# SERVICE NO. 1355B BULLETIN

Date: August 18, 2022

Service Bulletin (SB) 1355B supersedes SB 1355A in its entirety. Aircraft that were previously made compliant with SB 1355A are in compliance with SB 1355B.

**TEE BAR ASSEMBLY INSPECTION**

**Figure 1**  
Tee Bar Assembly – Weldment

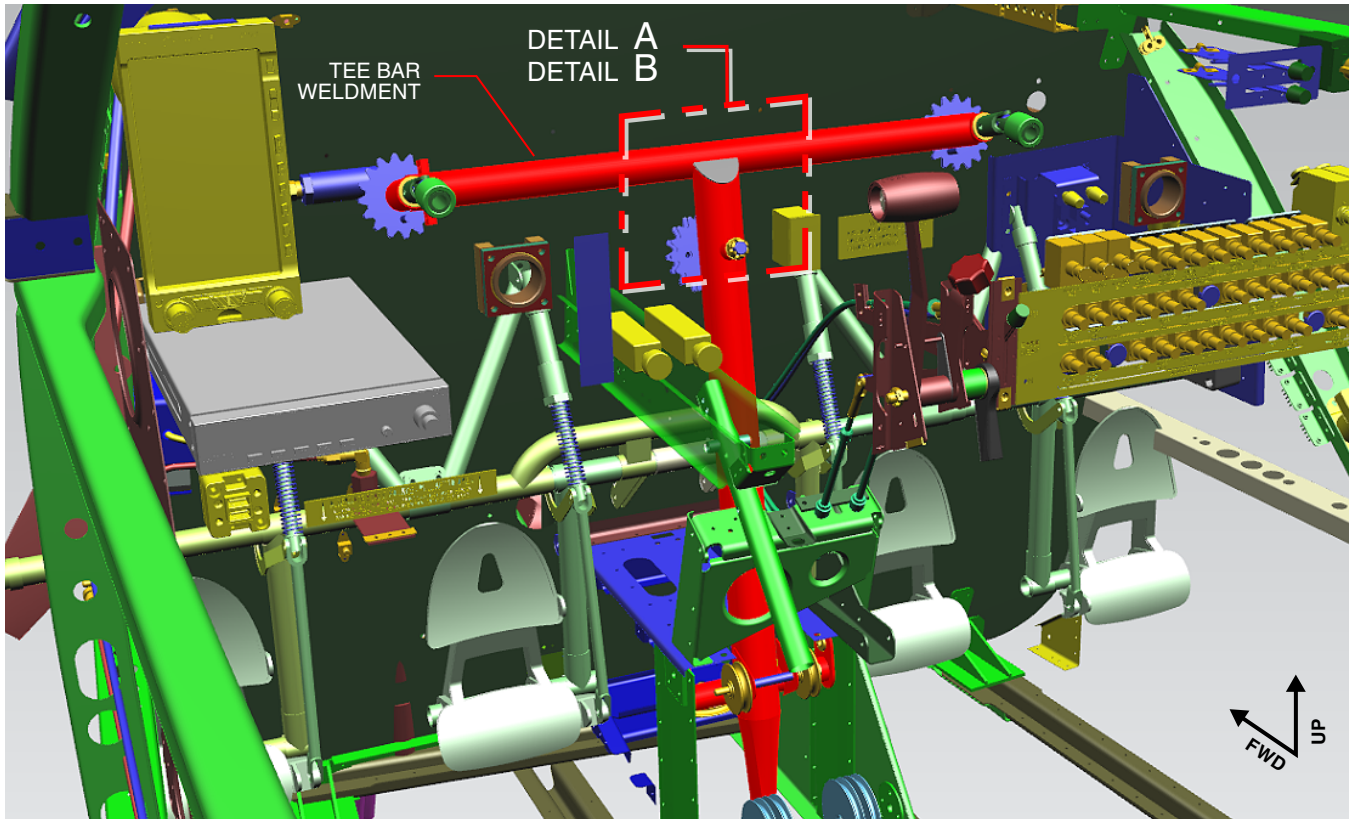
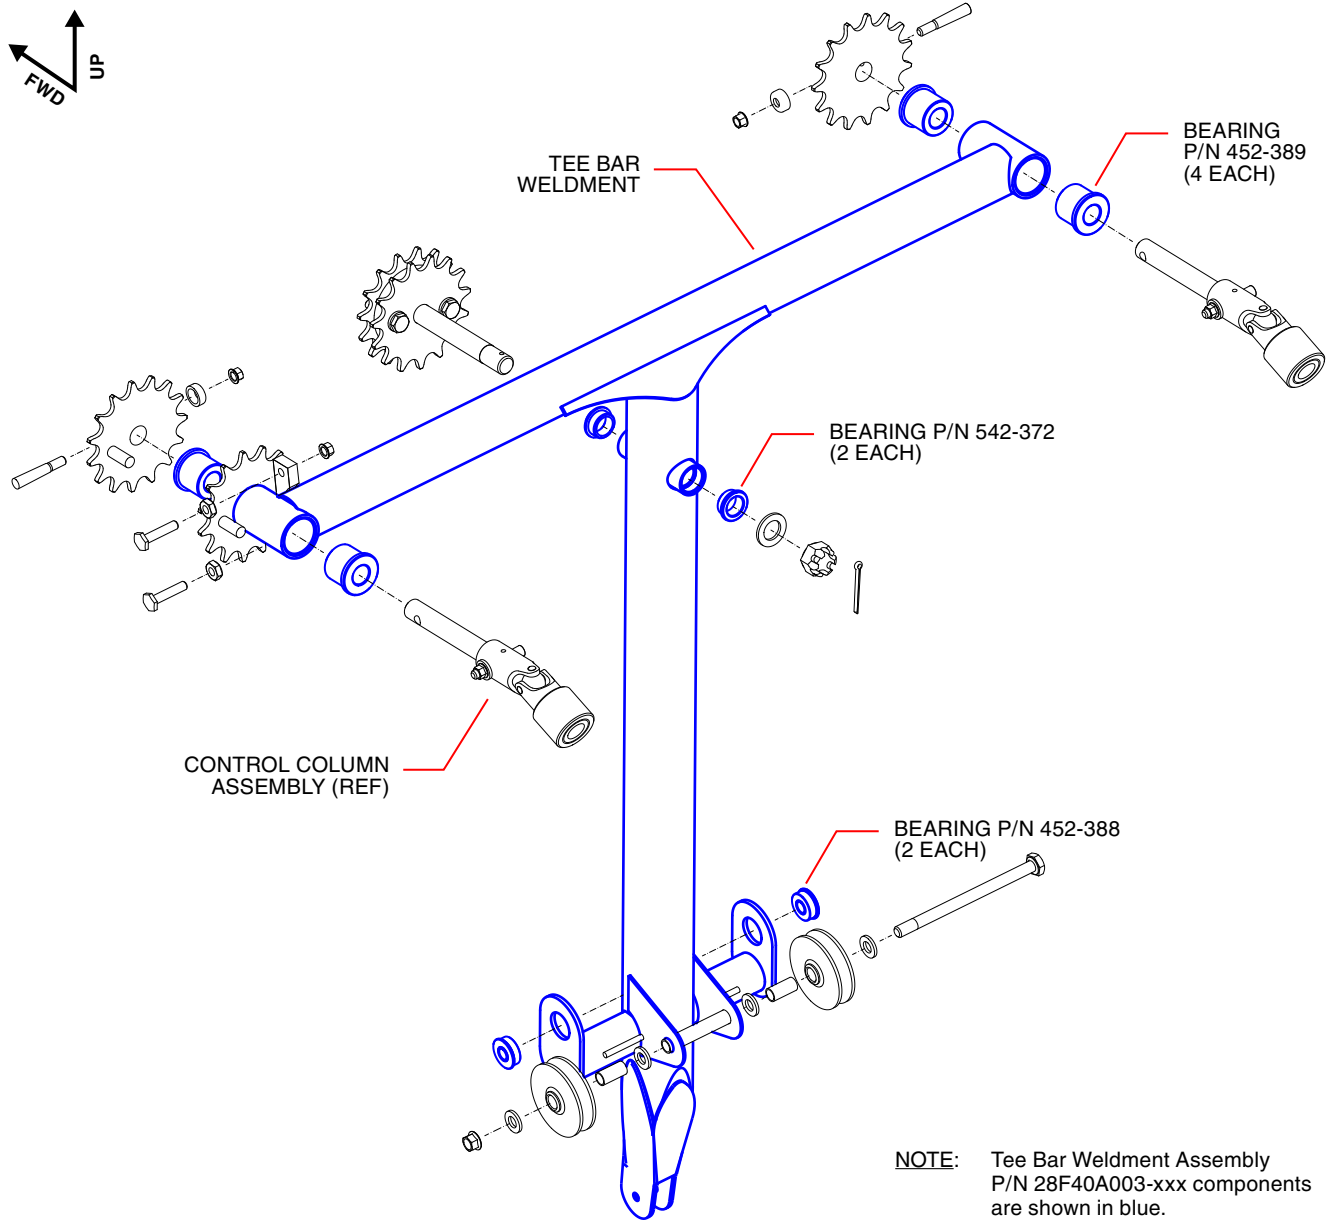
1. Gain visual access to the top center portion of the tee bar assembly, as shown in Figure 1. Identify the configuration of the tee bar weldment assembly.
  - If the local area conforms to Figure 1, Detail A, then recurring inspections are required. Proceed to Step 2.
  - If the local area conforms to Figure 1, Detail B, then the factory original tee bar assembly has already been replaced with a tee bar assembly containing the required features (i.e., gusset) and is already in compliance with Part II. Therefore, no recurring inspections are required. Proceed to Part II, Step 8.
2. Examine the area shown in Detail A for cracks, with special emphasis on welded joints.

- b. Perform a fluorescent dye penetrant inspection per FAA Advisory Circular AC 43.13-1B, Chapter 5, Section 5.
  - If any cracks are discovered, then the tee bar weldment must be replaced prior to next flight. Proceed to Part II.
  - If no cracks are discovered, apply primer and topcoat to bare metal, per the applicable Piper Airplane Maintenance Manual (AMM) or Service Manual (SM) and FAA Advisory Circular AC 43.13-1B, Chapter 6. Proceed to Step 3.

1. Order and install one (1) each, of the applicable tee bar weldment assembly, per Table 1.
2. To replace the tee bar weldment assembly, first, in accordance with Section 27-10-00 of the applicable Piper AMM or Section V of the applicable SM, remove the control wheels and the control column tee bar assembly from the aircraft.

**Figure 3**  
Brass Shim P/N 62833-152 Installation Location

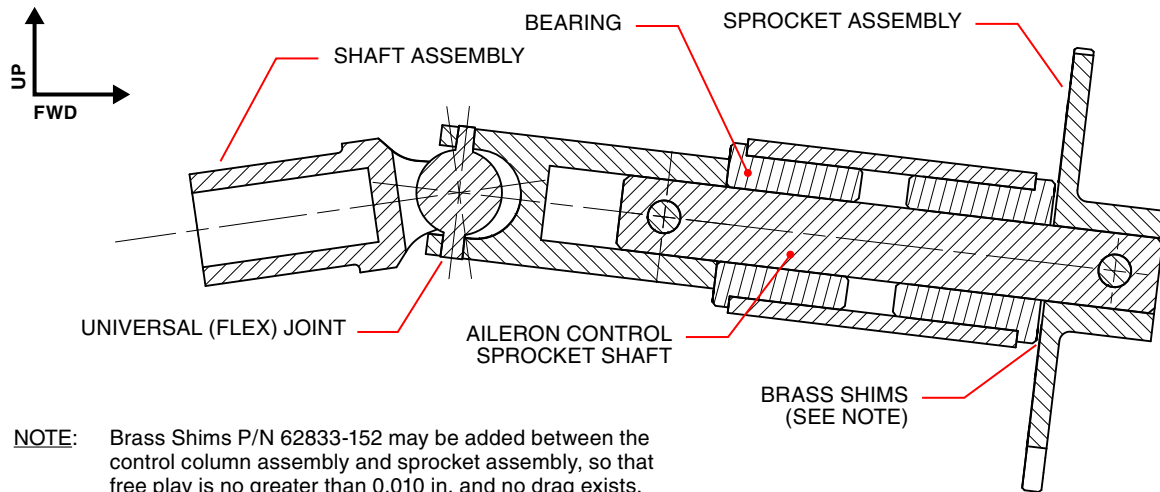
5. Reinstall the control column tee bar assembly and control wheel columns, in accordance with Section 27-10-00 of the applicable Piper AMM or Section V of the applicable SM. If necessary, so that there is no greater than 0.010 in. of free play (relative motion) and no drag exists between the control columns and sprocket assemblies, add Brass Shims, Piper P/N 62833-152, no more than two (2) per side, as shown in Figure 3.
